DESCRIPTIVE REPORT

Registry No. H11857

General Locality Columbia River

Sublocality Sandy Island to Bachelor Island

Figure 2. Artifacts in Reson 7125 bottom tracking algorithm

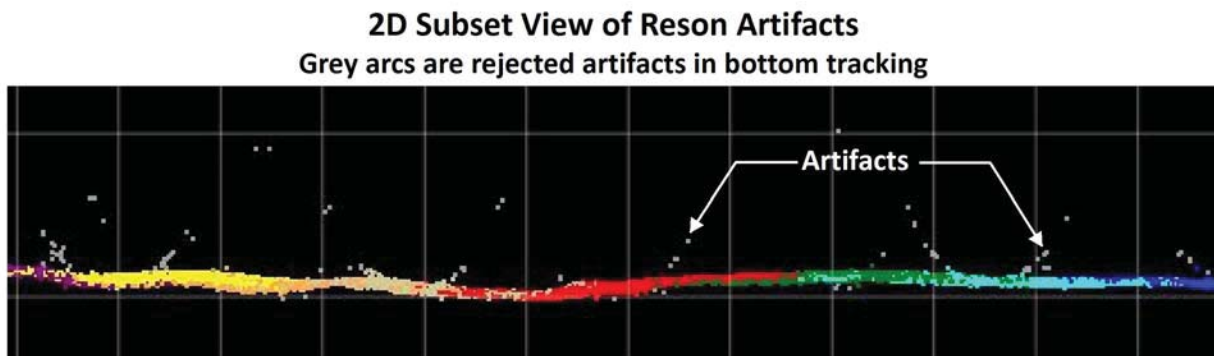
There is an error in the Reson 7125 bottom tracking algorithm that causes bottom detection (beams 86-115 and 140-168) to lock on to stronger sonar returns bleeding over from more nadir returns (Figure 2). This may be related to the amplitude bottom detection used near nadir and the bottom detection locking on to the strong nadir return signal, rather than the actual bottom return for that designated beam area. These artifacts occur in two areas near nadir and are more prevalent on a hard bottom, such as a dredged channel, when the amplitude of the nadir return is the strongest. The artifacts run along track and can exceed 20 cm in the raw soundings, but are reduced to 5 cm to 10 cm in the CUBE surface.⁹ Attempts to remove these artifacts during survey operations with changes in sonar settings were unsuccessful. Reson is aware of this issue and is working towards a resolution with a different bottom tracking algorithm.

⁹ Despite the artifacts from the bottom tracking algorithm, the data meets specification.

Figure 3. Shoaling and Obstructions at Elder Rocks behind Sandy Island

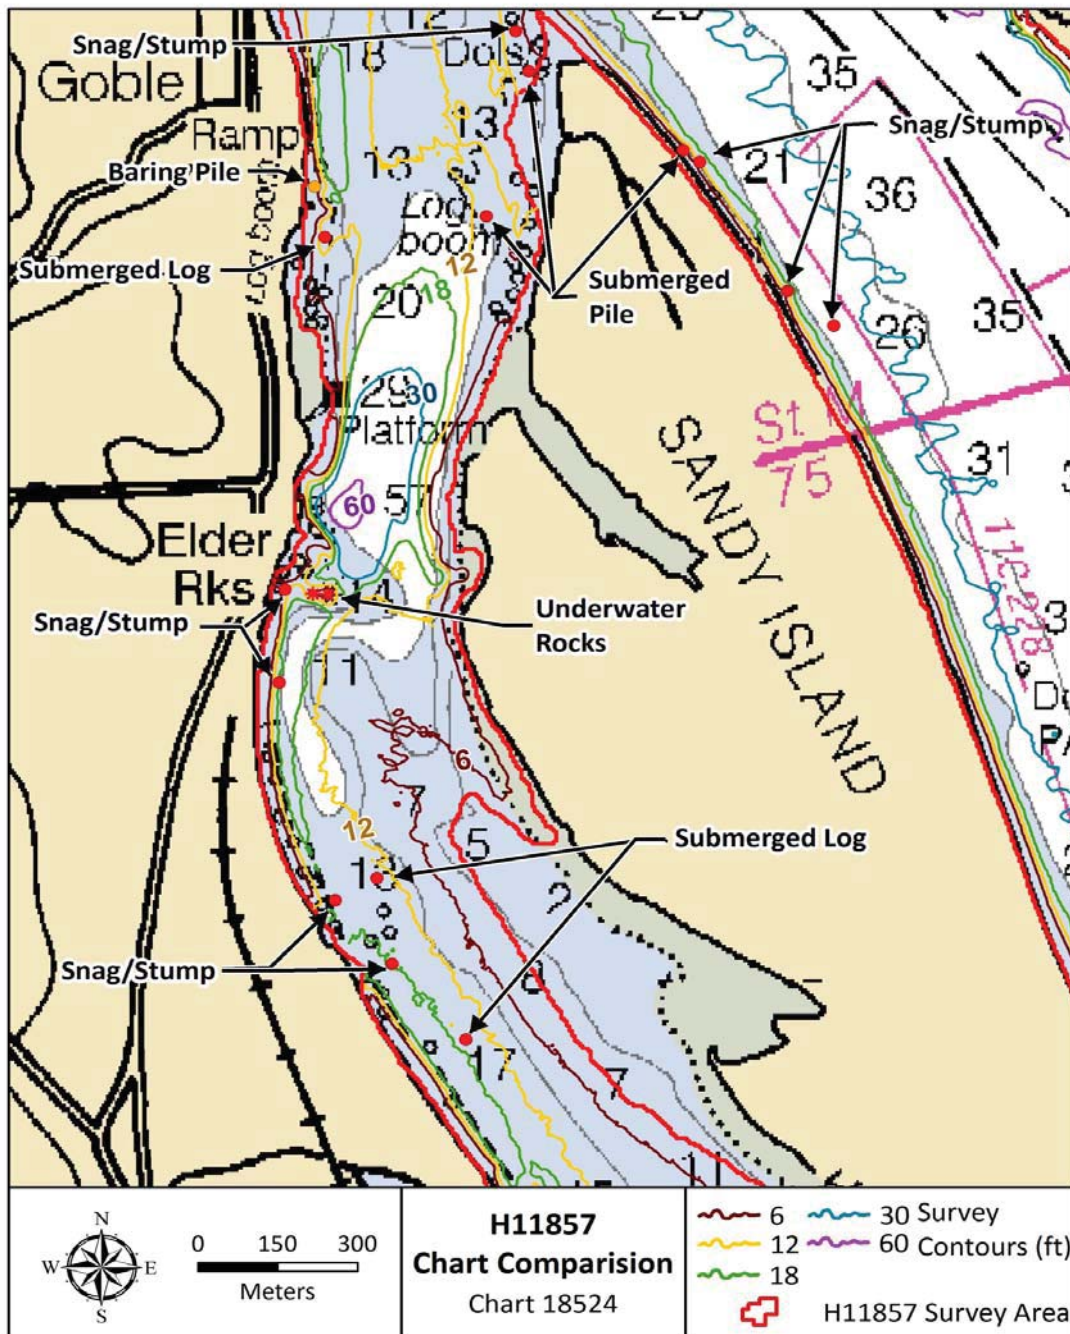
South of Elder Rock on the west side of Sandy Island significant shoaling has occurred (CRM 75). Current bathymetry reduces depths to 2-feet (0.7 m) where the chart shows a depth range of 8 to 11-feet. Numerous snags, snags, and an uncharted rock were located in this area (Figure 3) and are included in the S-57 feature file.¹⁸

¹⁸ Concur. The updated soundings and new features are included in HCell H11857.

Figure 4. Bachelor Shoal

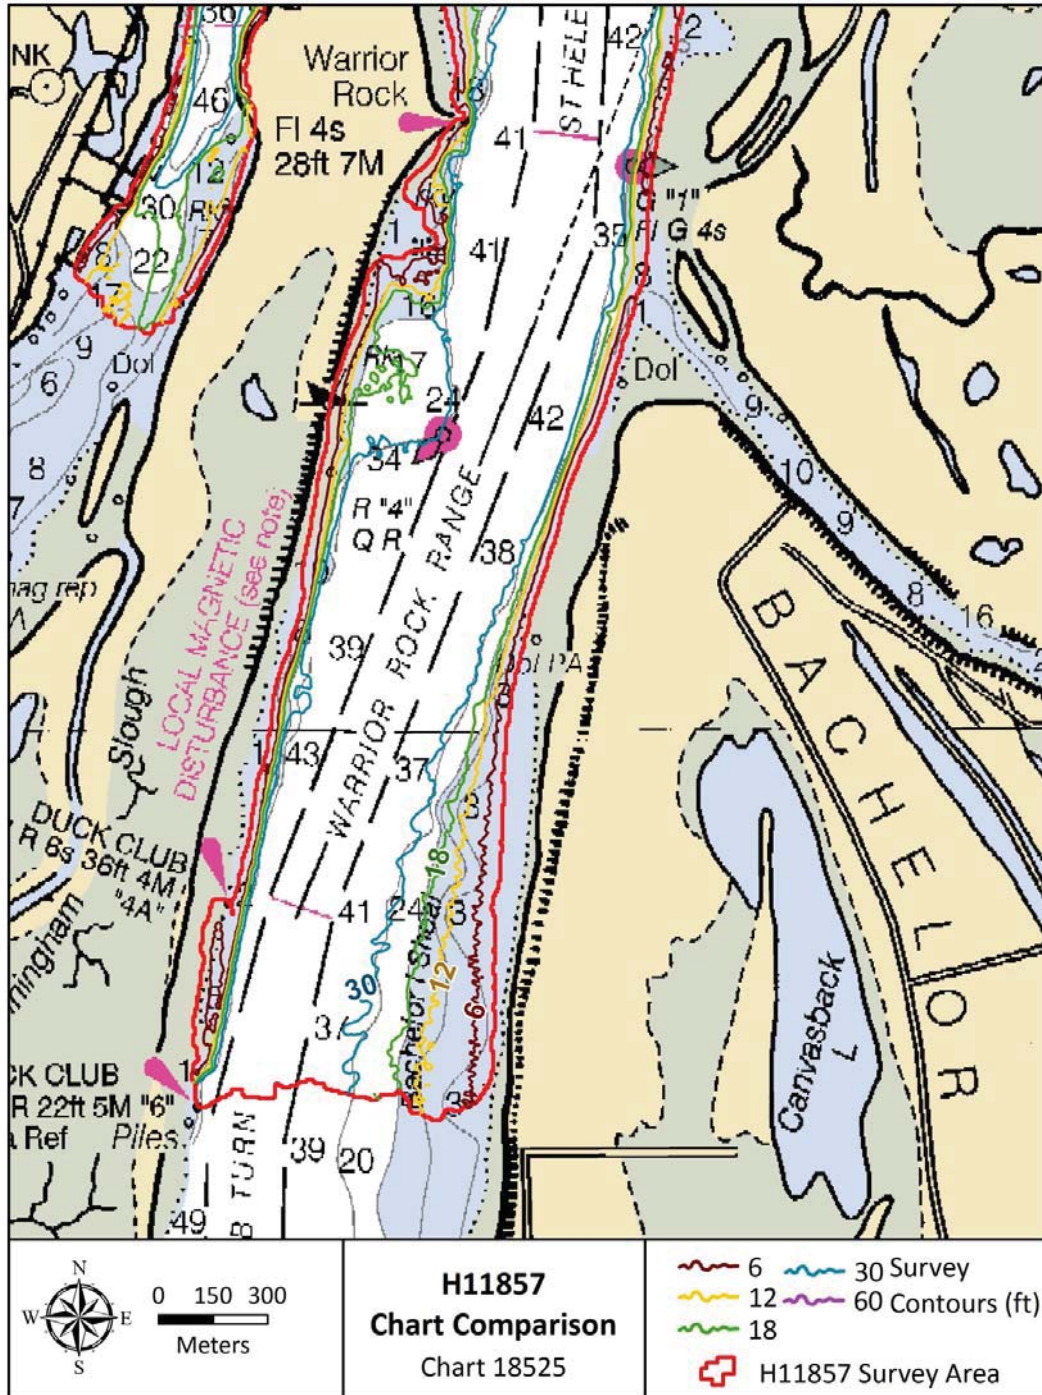
There is a general deepening trend near charted Bachelor Shoal at CRM89. Bachelor Shoal was surveyed to be 3 to 6 feet (0.9 to 1.8 m) deeper than charted (Figure 4).¹⁹

¹⁹ Concur. Updated soundings are included in the HCell.

Figure 5. New Gravel Conveyor

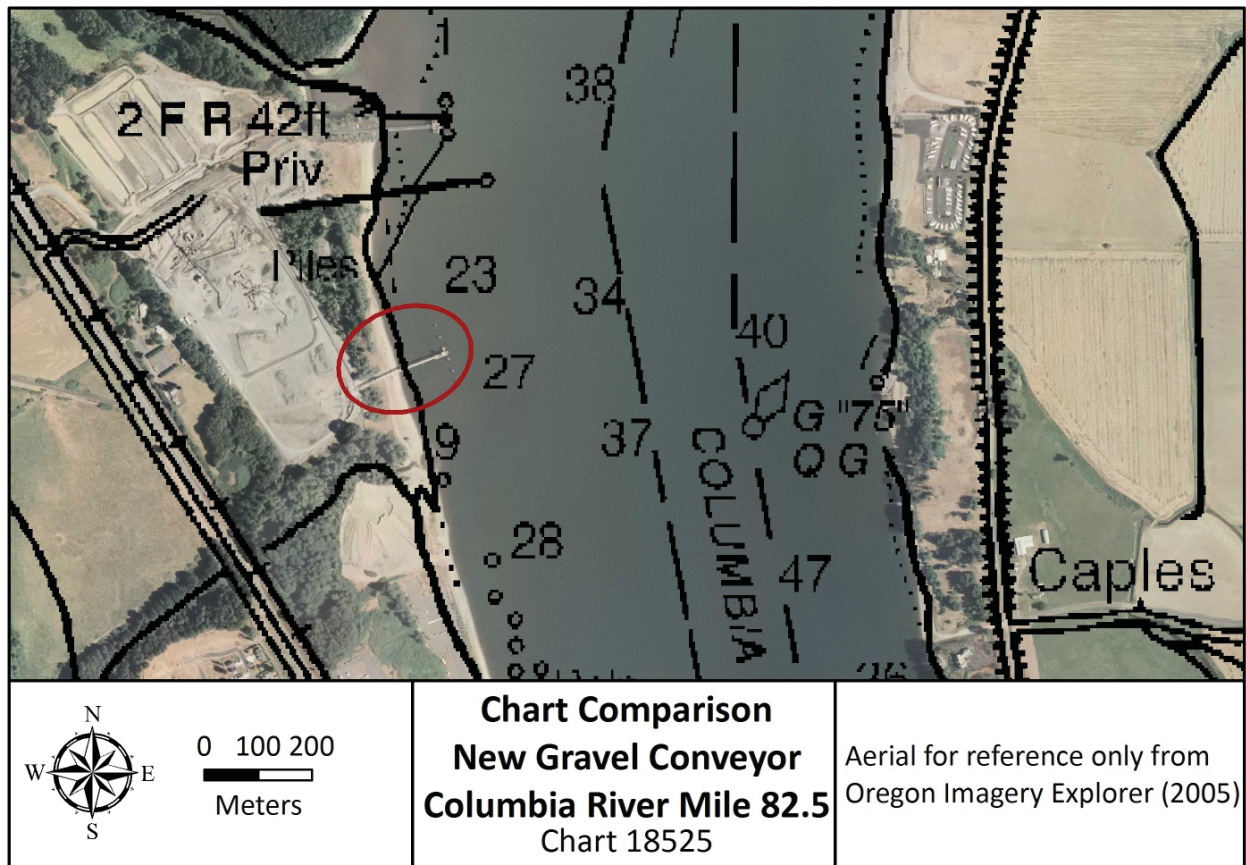
There is a new gravel conveyor loading facility (Figure 5) constructed with six new dolphins at approximately CRM 82.7.²⁷

²⁷ The new gravel conveyor and dolphins are included in the HCell.

Figure 6. Elevated Pipe

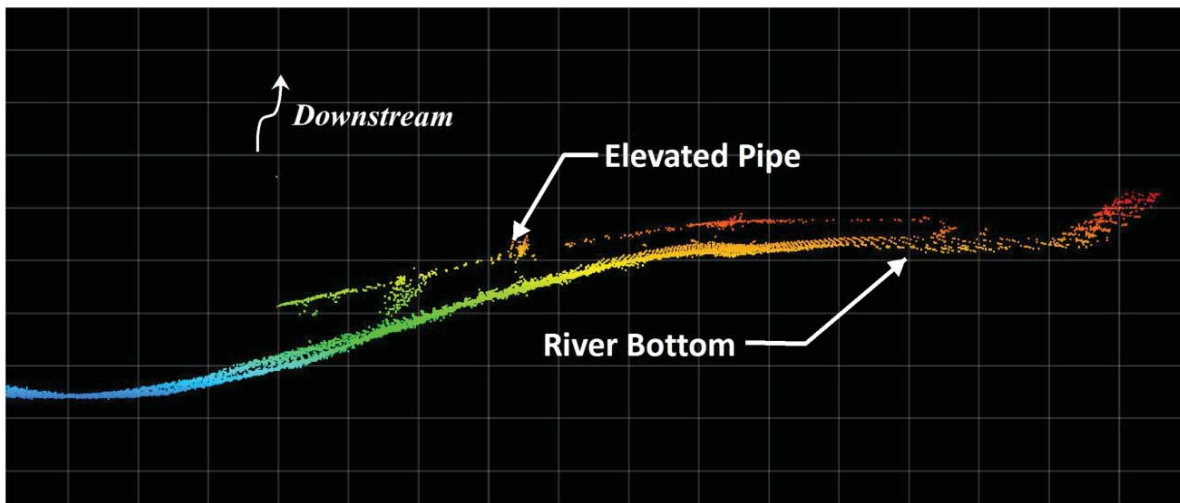
An uncharted, elevated pipe that is approximately 66 feet (20 m) in length was located south of the Kalama Marina adjacent to a charted dolphin at approximately CRM75.4 (Figure 6).³¹

³¹ Due to scale constraints, it is recommended that the charted dolphin be retained and the new pipeline not be charted.

Figure 7. Example of Sand Wave Migration

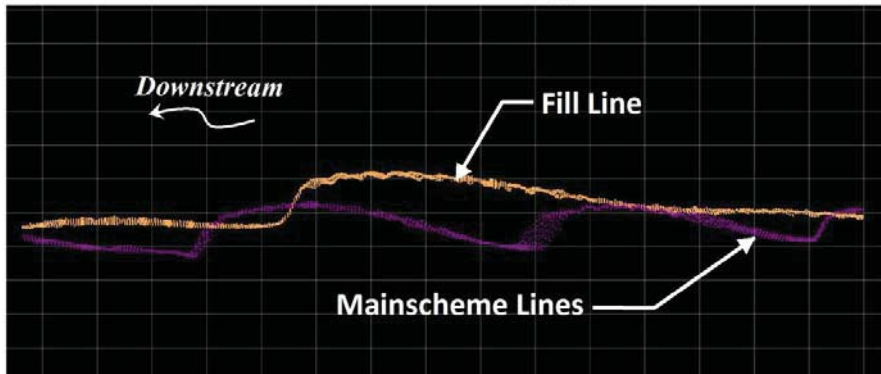
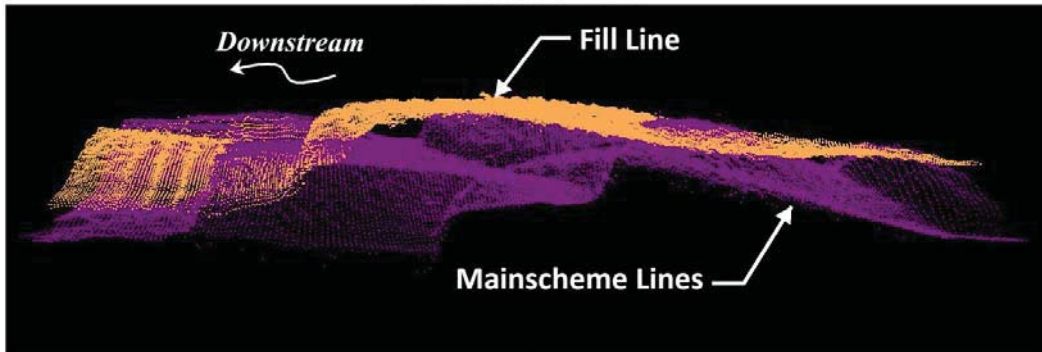
Although the survey exceeds IHO Order 1 accuracy requirements, environmental conditions degraded the quality of the survey data. Due to the dynamic nature of the Columbia River with its heavy sediment transport, sand wave migration (up to one meter of downstream migration per

day), has altered the river bottom over time, creating an offset between fill and mainscheme data.³³

The difference in offset varies over the survey, depending upon the local sand wave formation and the time between fill and mainscheme data collection. Figure 7 shows an example of downstream sand wave migration impacting agreement between mainscheme and fill data.

³³ These data are adequate to supersede charted data in the common area despite the shifting nature of the sandwaves. Compiler recommends a note be added to the chart stating that mariners use caution when navigating outside the maintained channels.
